Access Compliance Report

Public Rights-of-Way

Intersection ID: 52448	Main Street: WOODWARD_AV	Cross Street: DOUBLE_OAKS_RD	Location: E
ADA ID: 54894AFBDB5B	Ramp Type: MedianPerp	Initial Pass/Fail: Pass	Overall Compliance: No
		Severity Score: 5

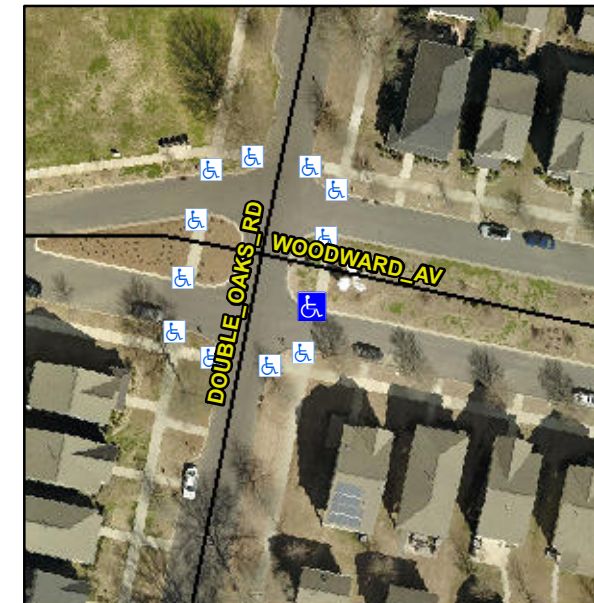
**R304.2.2-Perp, R304.3.2-Para,
R304.5.4**

**Remove & Replace Landing.
Remove & Replace Gutter.**
